**SUBJECT:** Princeton Executive Park (PB 19-15)  
Preliminary/Final Major Site Plan & Subdivision  
Block 9, Lots 12.01 & 12.03, Block 9.03 Lot 12.02  
VCEA Project No. 19-20-WW

**SUBJECT:** Princeton Executive Park  
Preliminary and Final Major Site Plan and Subdivision  
Planning Board Review Memorandum #1  
PB19-15  
US Route 1 North and Meadow Road  
Block: 9, Lots: 12.01 & 12.03  
Block: 9.03, Lot: 12.02  
West Windsor Township, Mercer County, New Jersey

Subject: Princeton Executive Park  
Preliminary and Final Subdivision Plan  
Preliminary and Final Site Plan  
Block 9 Lots 12.01 and 12.03; Block 9.03 Lot 12.02  
US Route 1 North & Meadow Road

SUBJECT: **Princeton Executive Park**  
**Preliminary/Final Major Site Plan & Subdivision (Hotel - Phase 1)**  
**Preliminary/Final Major Site Plan & Subdivision (North Residential – Phase 2)**  
**Preliminary Major Site Plan (Retail & Restaurant – Phase 3)**  
**Preliminary Major Site Plan (South Residential – Phase 4)**  
Block 9, Lot 12.01 and 12.03, and Block 9.03, Lot 12.02  
US Route 1 North, Meadow Road and Carnegie Center Drive  
PB19-15

## 11. Architectural Plan: Building Identification

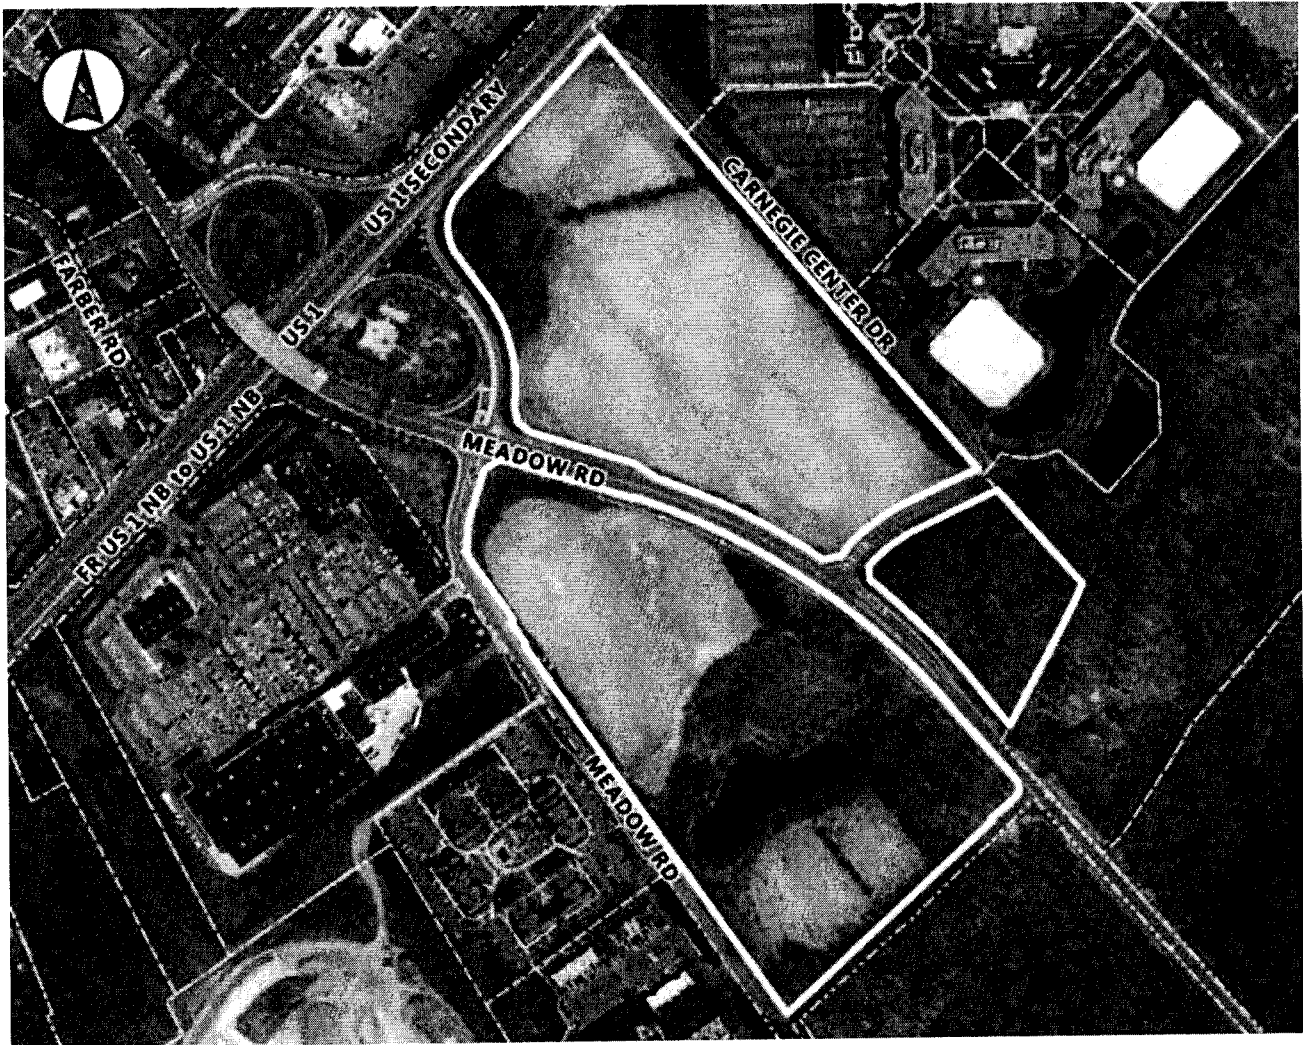
There is a discrepancy regarding the number of buildings between the site plan and the architectural plans. The building identified as Building 23 on the site plan is identified as Building 28 on the architectural plan. It appears as though the architectural plan does not identify a Building 23. This should be confirmed and corrected.

In addition to the above, Sheet A.113 of the architectural plan needs to highlight Building 22 as a Building Type C
